# Access Compliance Report

## Public Rights-of-Way

Intersection ID: 21888	Main Street: ROCKLEDGE_DR	Cross Street: WATERCREST_RD	Location: SW
ADA ID: 5C4F242799B3	Ramp Type: BlendTrans2	Initial Pass/Fail: Fail	Overall Compliance: No
		Severity Score: 10

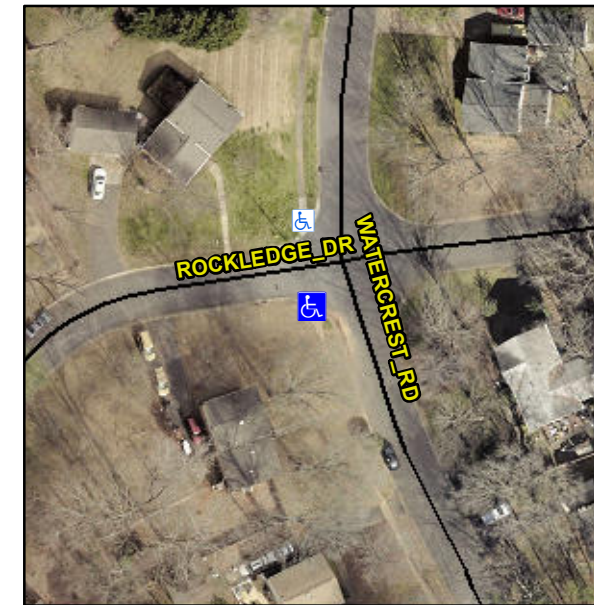
**Not Found, R304.5.1, R304.5.3**

Compliance	Description	Data	Compliance	Description	Data
N/A	Ramp Length (in)	84.0	Yes	BlendTrans Slope (%)	2.5
No	Ramp Width (in)	47.0	No	BlendTrans XSlope (%)	3.6
N/A	Flare Type LT	N/A	N/A	Flare Type RT	N/A
N/A	Flare Slope LT (%)	N/A	N/A	Flare Slope RT (%)	N/A
N/A	Flare Traversable LT?	N/A	N/A	Flare Traversable RT?	N/A
N/A	Landing Length (in)	N/A	N/A	DWS Provided?	N/A
N/A	Landing Width (in)	N/A	N/A	DWS Contrast?	N/A
N/A	Landing Slope (%)	N/A	N/A	DWS Length (in)	N/A
N/A	Landing X Slope (%)	N/A	N/A	DWS Full Width?	N/A
N/A	Landing Curb? (Y/N)	N/A	N/A	DWS Offset (in)	N/A
N/A	Shared Landing?	N/A			
N/A	Gutter Ponding?	N/A	N/A	Gutter Slope (%)	N/A
N/A	Gutter Lip Ht (in)	N/A	N/A	Gutter X Slope (%)	N/A
N/A	Painted X Walk1?	No	N/A	Painted X Walk2?	No
	X Walk 1 Direction	To E		X Walk 2 Direction	To N
	X Walk 1 Width (in)	N/A		X Walk 2 Width (in)	N/A
	X Walk 1 Slope (%)	1.5		X Walk 2 Slope (%)	4.0
	X Walk 1 X Slope (%)	3.7		X Walk 2 X Slope (%)	1.8

N/A	Ramp inside XWalk1?	N/A	N/A	Ramp inside XWalk2?	N/A
	Road Slope (%)	4.0		Clear Space?	N/A
	Road X Slope (%)	3.0	N/A	Clear Space to XWalk (in)	N/A
N/A	Any Obstructions?	N/A	N/A	Storm Grate/Utility Hazard?	N/A
	Obstruction Type			Storm Grate/Utility Type	
		N/A			N/A
			Yes	Surface Condition? (G/P)	Good
			No	Curb Slope (%)	21.0

**Remove & Replace Curb Ramp With Two New Directional Ramps or Equivalent.**
